DOUGLAS PLACE ESTATES SUBDIVISION

Engineering Comments: The following comments should be addressed prior to submitting the FINAL PLAT for acceptance and signature by the City Engineer:

APPLICATION NUMBER 3 DATE October 15, 2015

DETAIL SITE PLAN

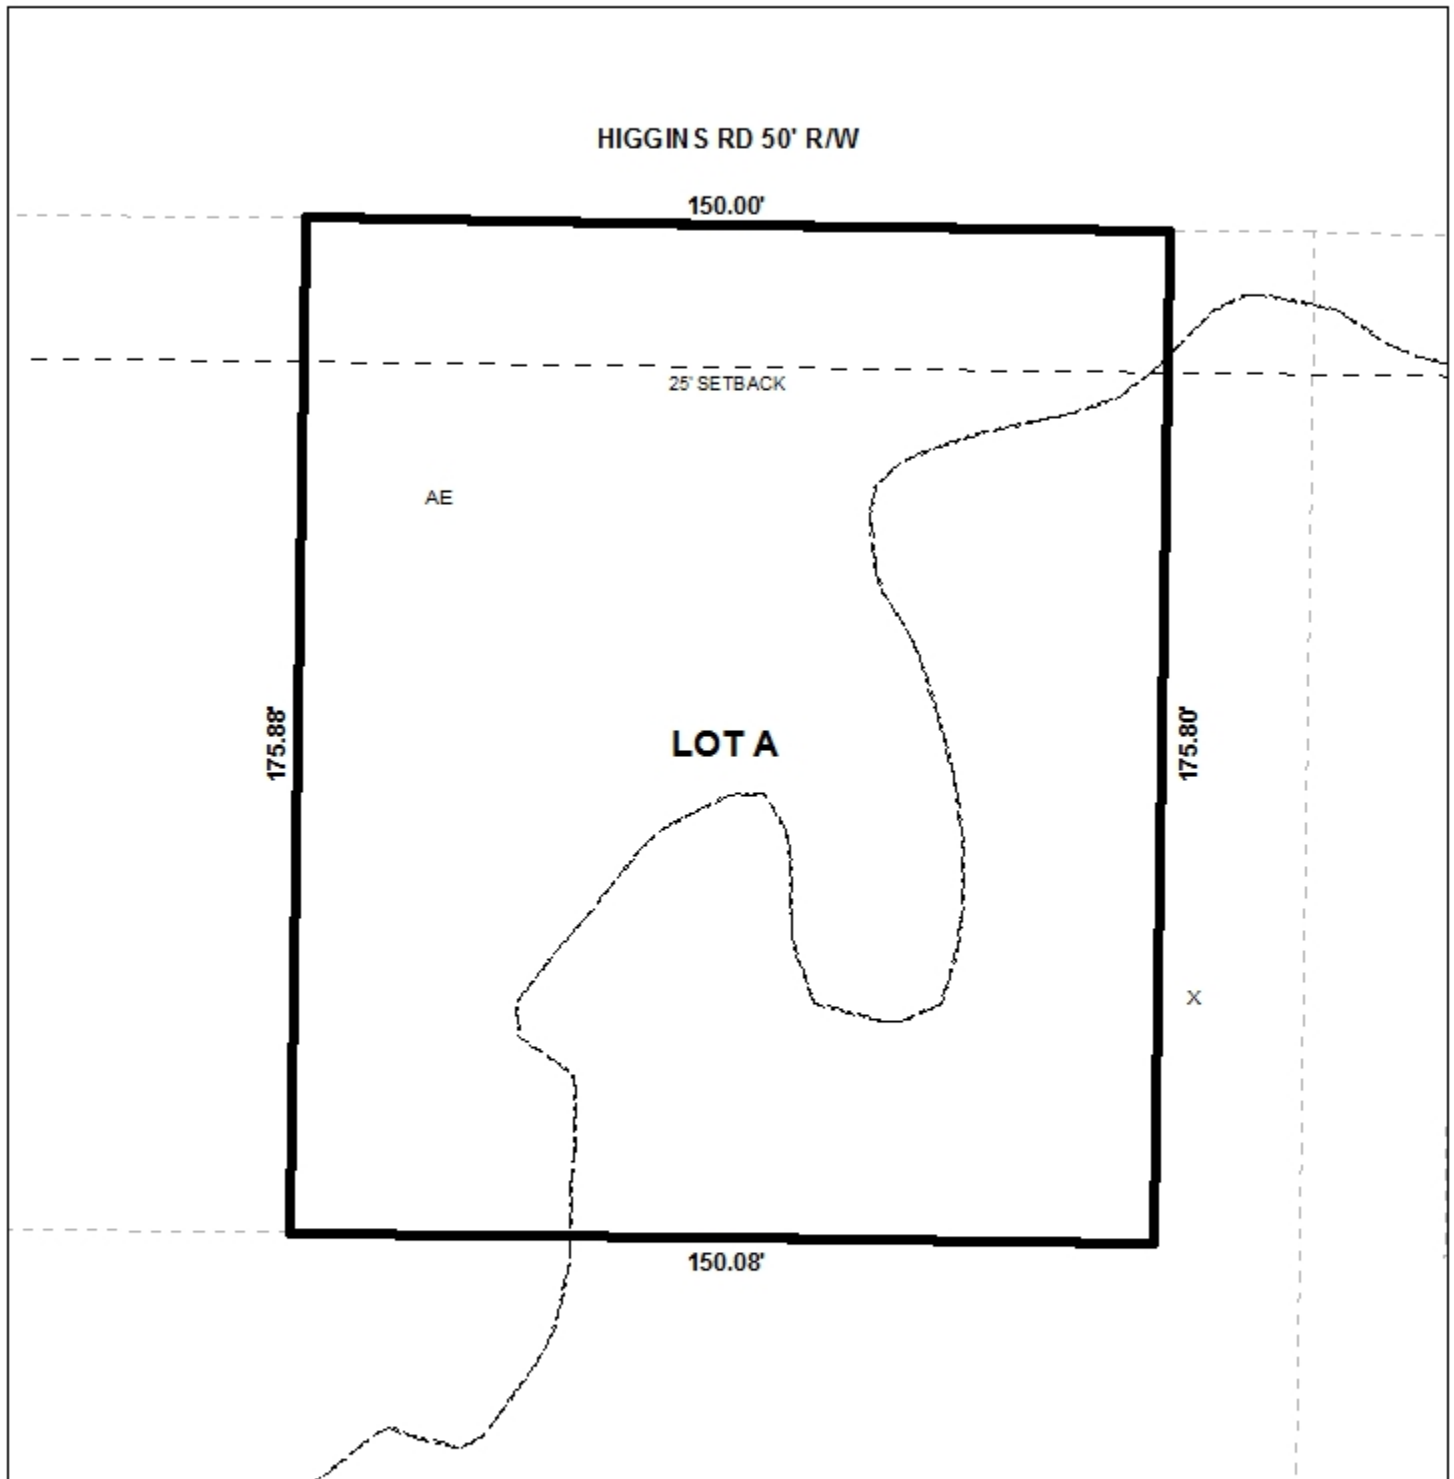
The proposed lot fronts Higgins Road, a minor street without curb and gutter. As a minor street without curb and gutter, this street requires a 60' wide right-of-way width. The existing right-of-way width is depicted as 50', thus dedication is required to provide 30' from the centerline.

The 25-foot minimum building setback line is depicted on the preliminary plat, and should be retained on the Final Plat, if approved.

As a means of access management, a note should be placed on the Final Plat stating that the lot is limited to the one curb cut to Higgins Road, with the size, location and design to be approved by Traffic Engineering and conform to AASHTO standards.

The preliminary plat does not depict the proposed lot size in square feet or in acres as required by Section V.D.2. of the Subdivision Regulations. This information should be indicated on the Final Plat, if approved.

- 1) Dedication to provide 30' from the centerline of Higgins Road;
- 2) Retention of the 25' minimum building setback along Higgins Road;
- 3) Placement of a note on the Final Plat to state that the lot is limited to one curb cut to Higgins Road, with the size, location and design to be approved by Traffic Engineering and conform to AASHTO standards;

- 4) Revision of the Final Plat to depict the lot size in square feet and in acres;
- 5) Compliance with Engineering comments (*The following comments should be addressed prior to submitting the FINAL PLAT for acceptance and signature by the City Engineer:*
